SPARC Enterprise™ M8000/M9000 Servers Product Notes

For XCP Version 1082

These product notes contain late-breaking information about the SPARC Enterprise™ M8000/M9000 servers hardware, software, or documentation that became known after the documentation set was published.

FIGURE 13-6 Card positioning post and card positioning tab

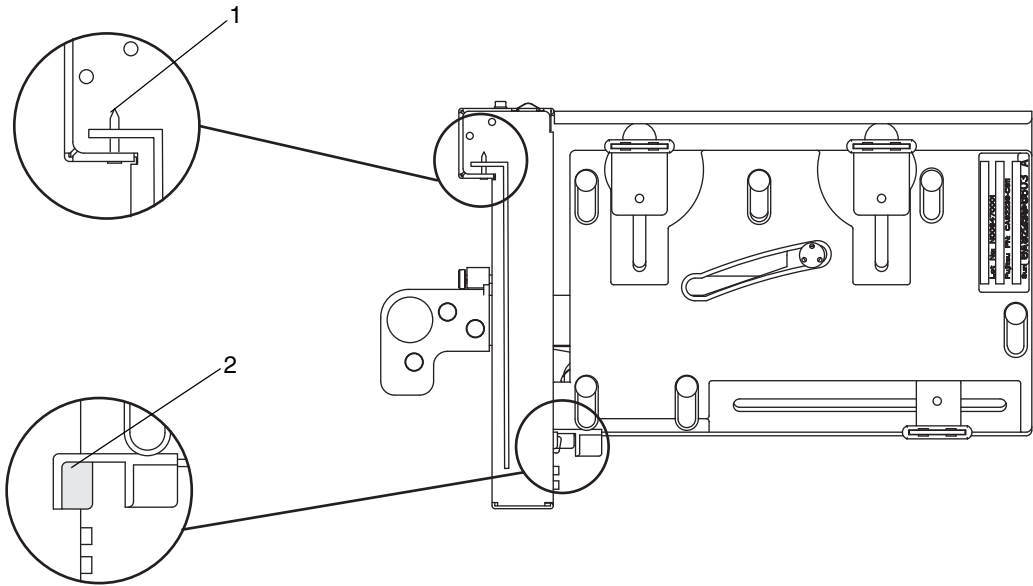
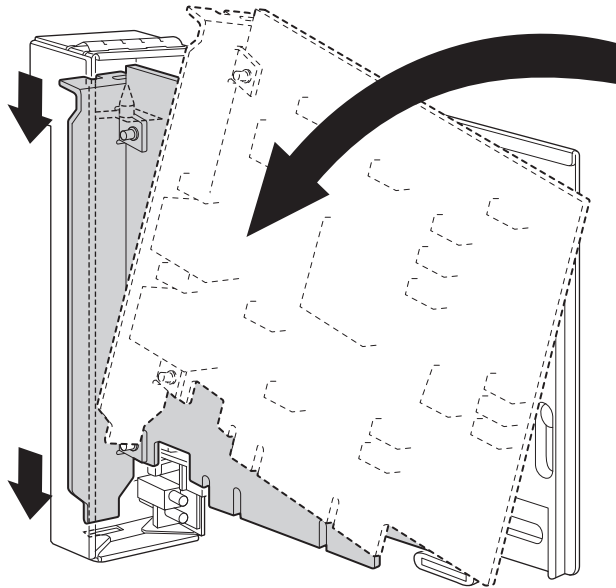
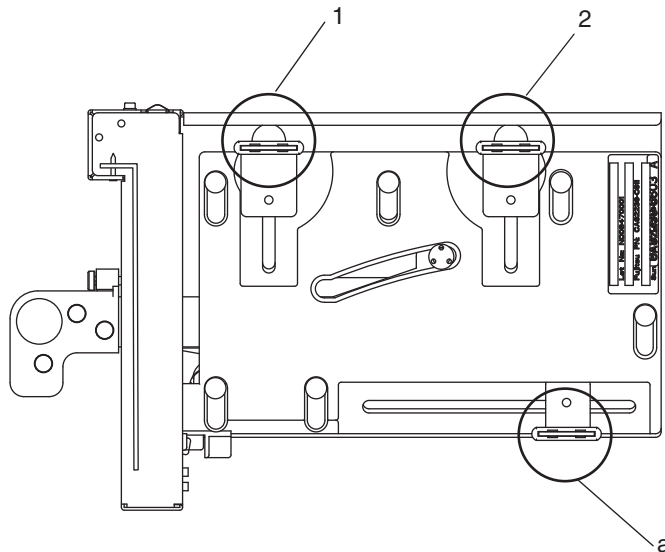
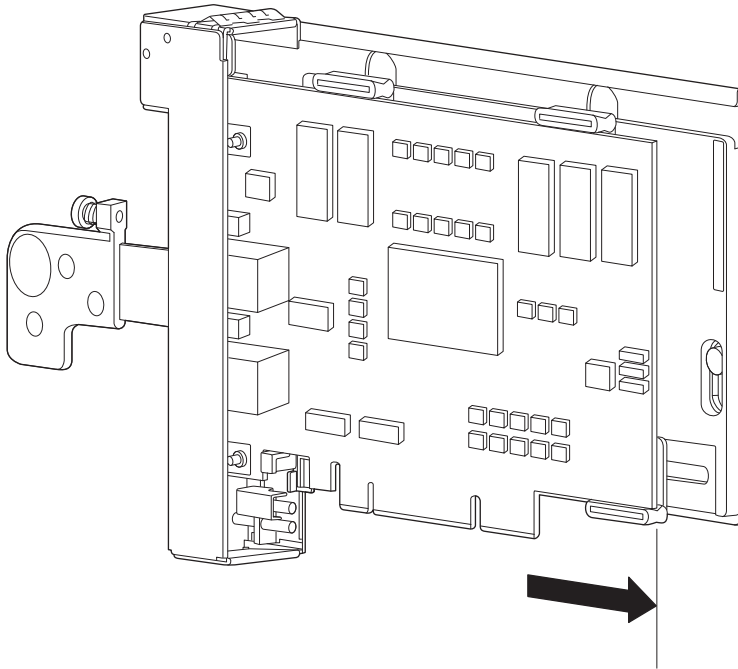
This is to correct step 9 in Section 13.2, "Active Replacement," of Chapter 13, "PCI Slot Device Replacement" on page 13-10.

The post (item 1 in [FIGURE 13-6](#)) is seated in the notch of the bracket of the PCI card. If the post is not properly seated in the notch, the mounting bracket of the card may be bent and the card may end up being affixed in an inclined position on the PCI cassette. If a card is affixed in an inclined position, it will not be in proper electric contact with the socket on the IOU.

The tab (item 2 in [FIGURE 13-6](#)) fits in the notch on the lower part of the PCI card. This tab is helpful in positioning the card when it is mounted on the PCI cassette (however, some types of cards do not have the notch).

- a. Move the PCI card in the direction of the arrow, and mount it on the PCI cassette by inserting the part projecting out at the bottom of the bracket of the PCI card into the hole at the bottom of the front panel of the PCI cassette and inserting the pin of the PCI cassette into the oval hole at the top of the bracket of the PCI card.

- b. Push the PCI card until the notched part on the base plate of the PCI card touches the card-positioning tab from the PCI cassette.

- c. Align the PCI card with the center part of the lower latch of the cassette. Then, while pressing the PCI card against the center part of each of the upper latches of the cassette, tighten the fixing screws in the sequence shown in [FIGURE 13-8](#) to fix the card in position.

Caution – If the card is short, move the screw at the bottom of the cassette as required. In such cases, place the latches as close as possible to the far end of the card ([FIGURE 13-9](#) reference). To shift the location of the bottom screw for the PCI card, first secure the card at the lower latch (part a in [FIGURE 13-8](#)). Then, tighten the fixing screws in the sequence shown in [FIGURE 13-8](#) to fix the card in position.
